# UNITED STATES PATENT AND TRADEMARK OFFICE

APPLICATION NO.	FILING DATE	FIRST NAMED INVENTOR	ATTORNEY DOCKET NO.	CONFIRMATION NO.
10/551,278	09/28/2005	Bob Roeloffs	R0100.0001	1554

<b>Office Action Summary</b>	<b>Application No.</b>	<b>Applicant(s)</b>	
	10/551,278	ROELOFFS, BOB	
	<b>Examiner</b>	<b>Art Unit</b>	
	RYAN VARNUM	4118

### **DETAILED ACTION**

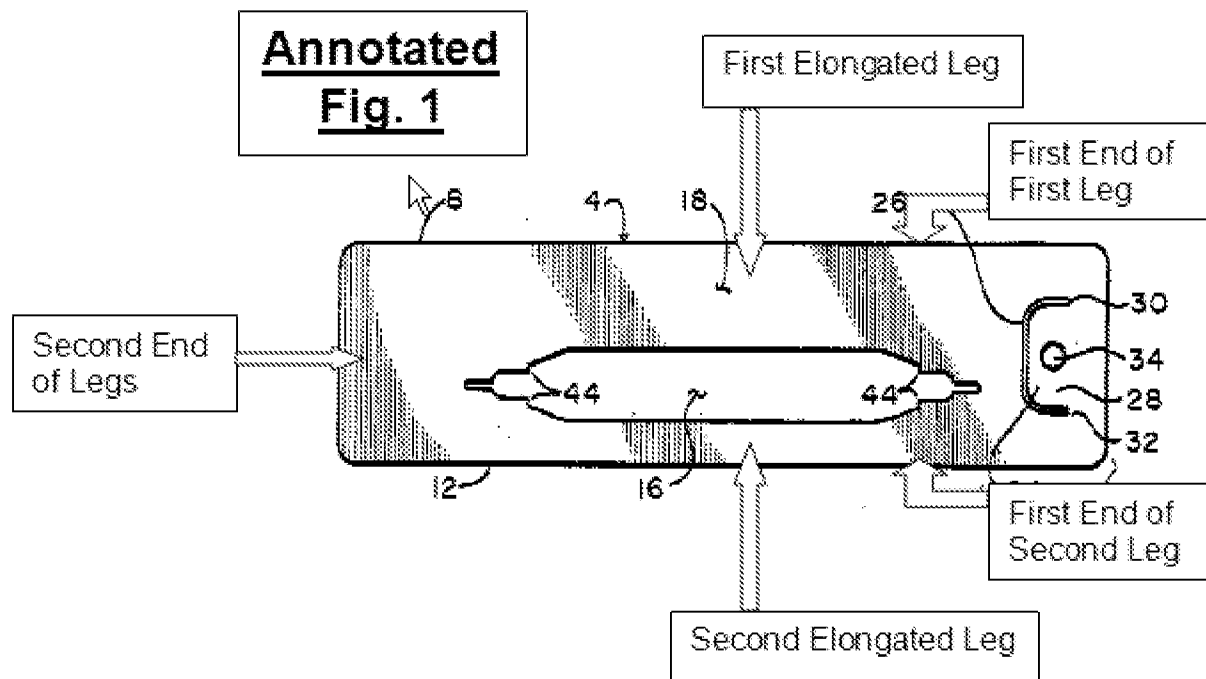
8. In re Claim 1, Dopp discloses a combination writing device (Fig. 1), comprising: a substantially flat writing member 20 (Fig. 1) which is provided with a writing tip 70 (Fig. 1), and at least a clamping device 4/24 (“card” and “tab”; Fig. 1) connected to the writing device for clamping the writing member in an edge area of a flat material, the clamping device comprising at least a first elongated leg and a second elongated leg which extend substantially parallel to an edge of the writing member facing thereto, the writing member and the clamping device take a fixed position relative to each other. (Fig. 1; See also Annotated Fig. 1 below; Column 2, Lines 47-51 and 64-68).

9. In re Claim 2, Dopp further discloses the first leg of the clamping device at an end thereof is connected to the writing member, and in that the second leg of the clamping device at an end thereof is connected to the writing member. (See Annotated Fig. 1 above; Fig. 2; Column 3, Lines 9-24).

10. In re Claim 3, Dopp further discloses the first leg of the clamping device at a first end thereof is connected to the writing member, in that the second leg of the clamping device at a first end thereof is connected to the writing member, and in that a second end of the first leg is connected to a second end of the second leg. (See Annotated Fig. 1 above; Fig. 2; Column 3, Lines 9-24).

11. In re Claim 4, Dopp further discloses the first leg and the second leg of the clamping device are connected to the writing member near the writing tip thereof. (See Annotated Fig. 1 above; Fig. 2; Column 3, Lines 4-24).
